INDESIT company

Model type:
AVSF109EU

Commercial code:
F034046

Fig . 001

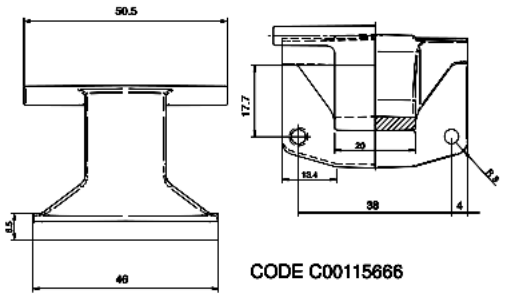
n1040349: Introduction of 150° Zamac hinge on Ariston 46 models.

From serial no. 50207.0001, all Ariston models produced in the Teverola factory (see table 001 attached) with industrial code (given on the rating plate) starting with 46, have been equipped with a Zamac hinge with 150° opening angle, code C00115666

(see Fig.001).
This modification has involved the introduction of the following items:

Code C00115670 - Complete door EVOII 150° white 27 with standard glass;
Code C00115674 - Complete door EVOII 150° white 27 with long glass;
Code C00115667 - EVOII body for 150° hinge white 27;

The premodified items are not interchangeable separately with the modified ones.

Code C00110133 - Complete door EVOII Standard 180° white 27 standard glass;
Code C00092157 - Complete door EVOII 180° white 27 long glass;
Code C00096193 - EVOII body for 150° hinge white 27;

The hinge code C00064541 continues to be used on the build-under models produced in the Comunanza factory.

Fig . 001

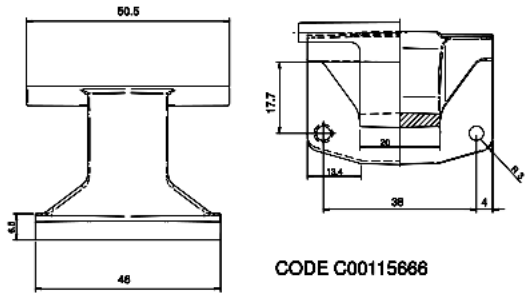
n1040353: Introduction of 150° Zamac hinge on Ariston models (Comunanza).

From serial no. 50207.0001, all Ariston models produced in the Comunanza factory (see table 001 attached) with industrial code (given on the rating plate) starting with 80, have been equipped with a Zamac hinge with 150° opening angle, code C00115666 (see Fig.001).
This modification has involved the introduction of the following items:

Code C00115670 - Complete door EVOII 150° white 27 with standard glass;
Code C00115674 - Complete door EVOII 150° white 27 with long glass;
Code C00115668 - Complete door EVOII 150° silver with standard glass;
Code C00115673 - Complete door EVOII 150° silver snella standard glass;
Code C00115662 - EVOII body for 150° hinge white 27
Code C00115663 - EVOII body for 150° hinge silver 27
Code C00115664 - Snella EVOII body for 150° hinge white 27
Code C00115665 - Snella EVOII body for 150° hinge silver

The premodified items are not interchangeable separately with the modified ones.

Code C00096416 - Complete door EVOII LB 180° standard depth silver;
Code C00097374 - Complete door EVOII 180° WD 180° white 27 long glass;
Code C00110133 - Complete door EVOII Standard 180° white 27
Code C00110178 - Complete door EVOII Snella 180° Silver;
Code C00091836 - EVOII body white 27 for 180° hinge;
Code C00094306 - EVOII body silver for 180° hinge;
Code C00094305 - Snella EVOII body white 27 for 180° hinge;
Code C00094307 - Snella EVOII body silver for 180° hinge;

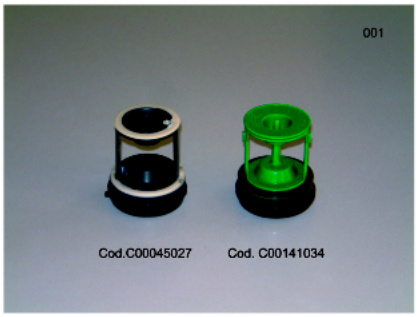
n1040376: Drain pump with filter with pin.

A new drain pump with filter with pin has been introduced progressively as from serial no. 50609.0001.

New parts:
C00119307 - Drain pump with pin filter;
C00141034 - Askoll / Plaset drain pump with pin filter kit (figure 001);

Premodification parts:
C00092264 - Drain pump;
C00045027 - Askoll / Plaset pump filter kit (figure 001);

The new parts can be used on all WASHING MACHINES previously equipped with the premodification parts.
